558 Scarlett Road and 13 Chapman Road – Rezoning Application – Final Report

Date:	August 24, 2007
To:	Etobicoke York Community Council
From:	Director, Community Planning, Etobicoke York District
Wards:	Ward No. 2
Reference Number:	File No. 06 193639 WET 02 OZ

This report reviews and recommends refusal of the application to amend the Zoning By-law.

Attachment 1: Site Plan

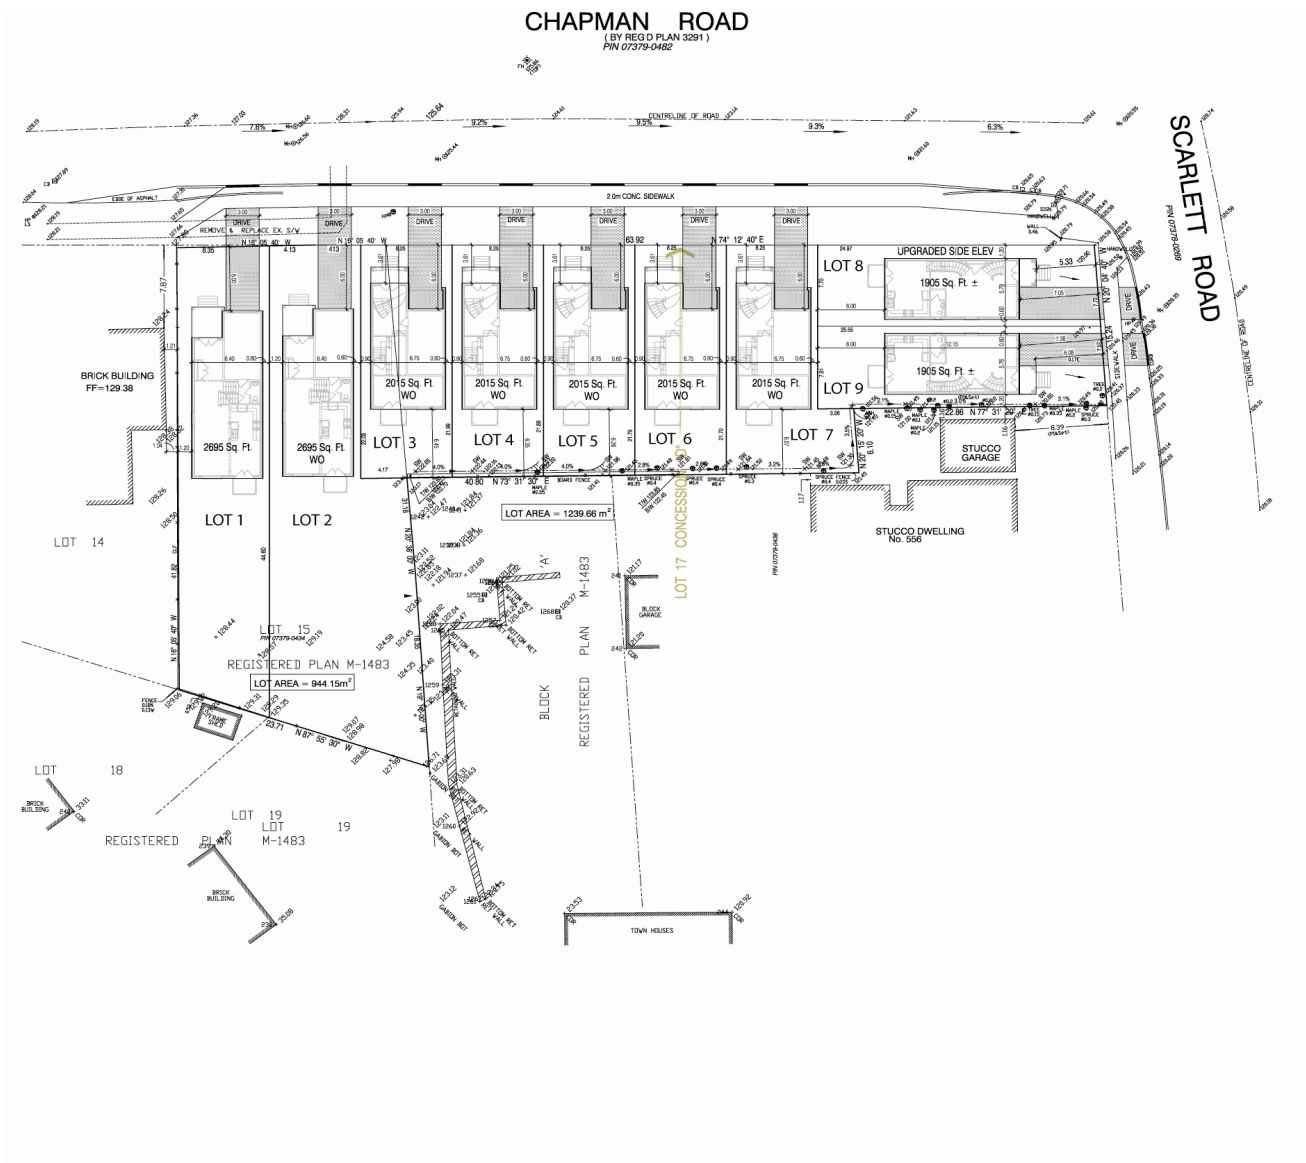
The topography of the site is proposed to be significantly altered with substantial regrading, filling, terracing and use of retaining walls to accommodate this development. In some areas, over 3 metres of landfill is required to create buildable parcels. A retaining wall ranging from 0.5 metres (1.6 feet) to 1.8 metres (6 feet) in height is proposed along the majority of the rear lot lines for Lots 3 to 7. Currently, a minimal grade difference exists with the southerly adjacent properties on Scarlett Road.

In most cases, rear yards of less than 6.5 metres in depth are proposed, whereas the Zoning By-law requires a rear yard setback of 25% of the lot depth, and minimum of 7.5 metres. The majority of the already undersized rear yards will likely be encumbered by a 2 metres wide drainage easement or restrictive covenant, placing further restrictions on the use and enjoyment normally associated with the rear yard of a single family dwelling including tree planting, storage shed, swimming pool, vegetable garden, paved patio/pathway areas, etc.. Further, the imposition of oversized dwellings at the proposed rear setbacks will cause privacy, light blockage and view concerns to the southerly adjacent properties.

The proposal indicates a front yard setback of 3.6 metres for the majority of the lots on Chapman Road, whereas the Zoning By-law requires a minimum of 7.5 metres. A 1.5 metre covered front porch projection plus additional steps will further encroach into this already limited area. The combination of a narrow lot frontage along with areas occupied by a paved driveway, covered porch and steps will leave a negligible amount of space available for soft landscaping, and will have no semblance to the standard found within the surrounding area. Further, the imposition of an oversized dwelling at this setback further contributes to an unwanted precedent in terms of streetscape for this community.

The concerns of the Development Engineering Section of the Technical Services Division as found in Attachment No. 8 are summarized as follows:

- Insufficient pervious area to accept stormwater runoff (causing sheeting and icing over proposed sidewalk, perpetually soggy rear yard conditions, etc.) not consistent with City's stormwater management philosophy
- Surface drainage from majority of lots to discharge through one lot onto the public roadway is neither fair nor acceptable

- Proposed armour stone retaining wall for only certain portions of the south property limit that is not continuous, is not effective in eliminating surface drainage penetration, is removable by the owner, and marginally reduces the effective use of the backyard.
- Drainage through the centre of a rear yard is not a desirable option
- All post development drainage should be self contained

- Final 2 metres of rear yard for Lots 3-7 will be subject to a surface drainage easement or restrictive covenant, compromising the use and enjoyment of an already limited rear yard. This includes tree planting.

A significant portion of the site is presently lower than the road. The portion of the roadway fronting the development site presently operates as a rural configuration that utilizes a ditch to convey road drainage. In order to ensure the proposed driveways maintain positive slope towards the roadway (avoiding integral garage designs that are lower than the roadway that are susceptible to flooding) and to eliminate the road ditch, the elevation of the site will need to be raised in conjunction with the urbanization of this portion of the roadway including provision of sidewalk and curb and gutter.

Raising the elevation of the site will necessitate provision of a retaining wall for certain portions of the site to prevent surface drainage from adversely affecting adjoining properties. A continuous poured concrete retaining wall that extends along the entire south property limit of the site (including the lots fronting on Scarlett Road) will be more effective in containing all surface drainage. The Site Plan indicates a proposed armour stone wall retaining wall which is not continuous, is not effective in eliminating surface drainage penetration, is removable by the owner, and marginally reduces the effective use of the rear yard. Useable rear yard ground space is further reduced by the proposed rear yard decks.

One of the lots is graded to convey the drainage through the centre of the rear yard, a less than desirable option.

Although the condition presently already exists, the largest lot in the proposed development continues to direct post development surface drainage onto the adjoining property to the east. All post development drainage from the site should be self contained.

In order for the surface drainage system to work as proposed in future, it needs to be defined and protected by either an easement or a restrictive covenant registered on title on each of the affected lots. This restricts the use and what can be erected within the last two metres of rear yards that are only six metres deep. It is noted on the Landscape Plan that trees are to be planted within the area that is to be designed for drainage which will impede the flow and is not acceptable. Typically these easements/covenants require the owner to provide and maintain surface drainage within and through their property by conveying upstream drainage through their lot to the adjoining downstream property. Restricting the use of two metres of all the properties further comprises the use and enjoyment of the already limited rear yard space.

The surface drainage system as proposed collects storm water from several properties and conveys it to a single lot which is neither fair to that prospective owner nor acceptable to City in terms of a single discharge point.

A french drain system similar to the system being proposed but one which includes both a surface and subsurface drainage system would be preferred, however such a system relies on the provision of catchbasin and a storm sewer connection which is contradicts the City's storm water management philosophy and would require special approval. Further, although this system would provide a better engineering solution, it is best suited to condominium corporation tenure. Whereas it is feasible for implementation for single-family tenure, administratively it is more onerous for the prospective owners.

Elevations - Floor Plans

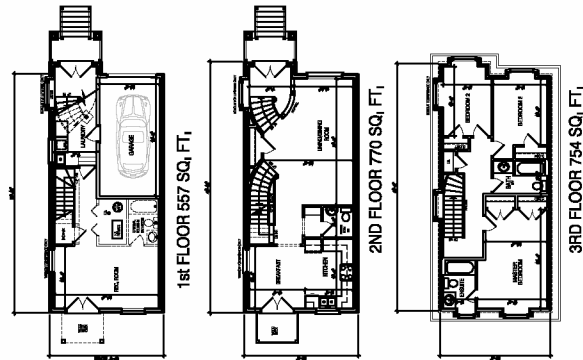
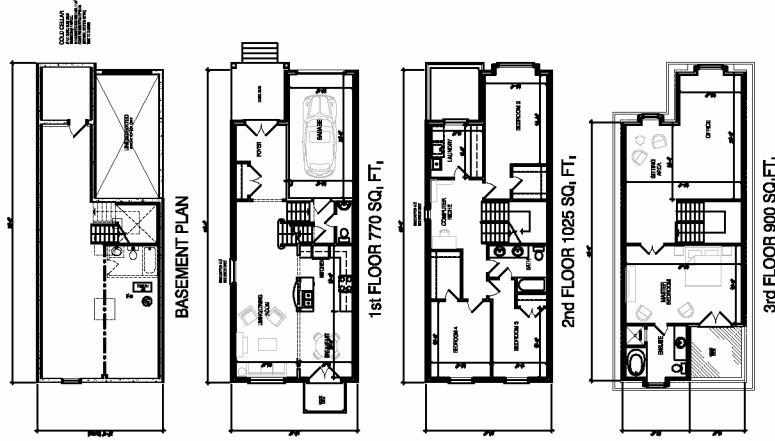
There is no precedent in the area for 3-storey, flat roofed single detached dwellings or the proposed heights of up to 13 metres, measured from the average unaltered property grade near the proposed front setback line. The Zoning By-law requires this method of measurement to discourage the manipulation of grading to achieve lower heights, and to provide for a full indication of the ‘before and after’ height impact between new and existing development. For example, the properties to the south of 558 Scarlett Road will be in view of rear dwelling walls with heights in excess of 10m atop new lots that in some instances contain over 3m of landfill above the existing grade. In the case of Lot 3, the majority of the west side lot line including the entire rear yard portion will be impacted by a neighbouring building height of approximately 12.5 metres (41 feet) measured at the proposed finished grade.

In all instances, the height issue is further compounded by the employment of flat roofs to achieve a full third storey on the dwellings. This restricts the passage of sunlight significantly more than a conventional sloped roof atop the one or two-storey portions of dwellings typically found within this neighbourhood.

The proposed building heights are out of character with the area and pose unacceptable impacts in terms of natural light access, privacy and shadowing.
